1953 - 1954 Corvette: Service News: Powerglide Clutch Interference

Subject: Powerglide Clutch

Model and Year: 1953 - 1954 Corvette

Date: October, 1957 - Volume 29- Number 10

Fig. 2—Powerglide Valve Body Re-worked.

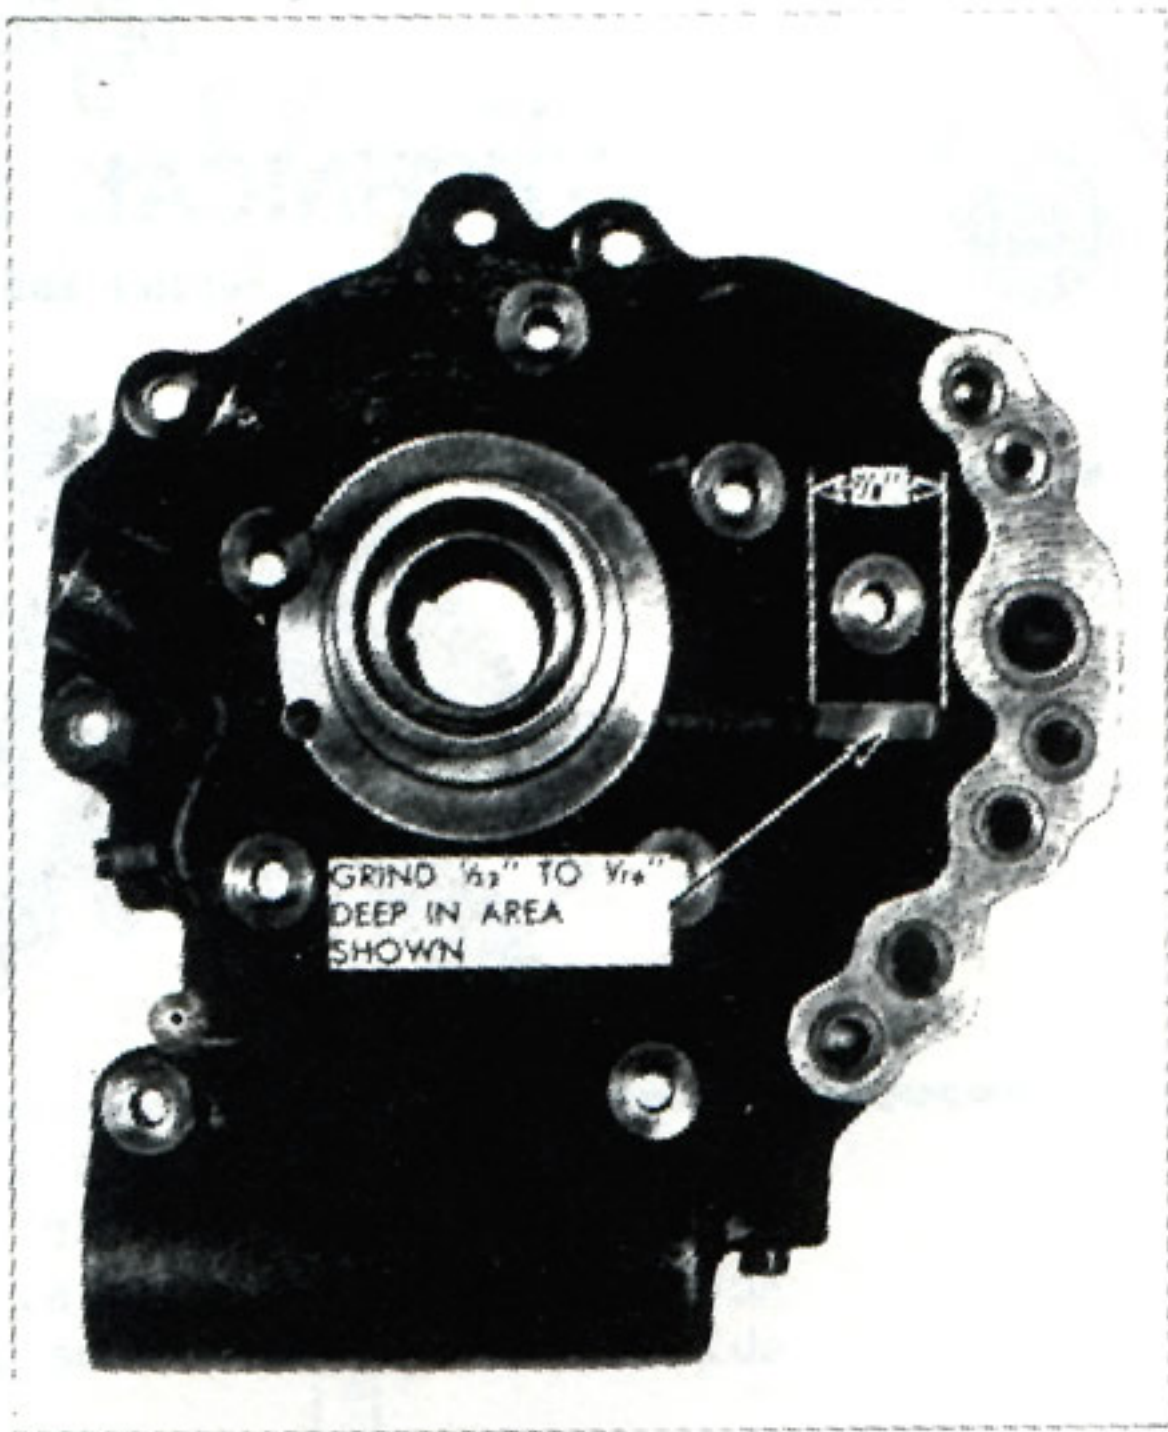
Due to limit stack conditions, a point of interference is possible when using a service replacement clutch drum or clutch assembly in 1953-54 Powerglide transmissions. The difficulty is caused by a ledge incorporated on the front face of a service replacement clutch drum, which can contact an embossed area on the valve body casting.

Where clutch drum-valve body interference is noted when installing one of the above assemblies the valve body must be reworked to obtain drum operating clearance, as shown in Figure 2.
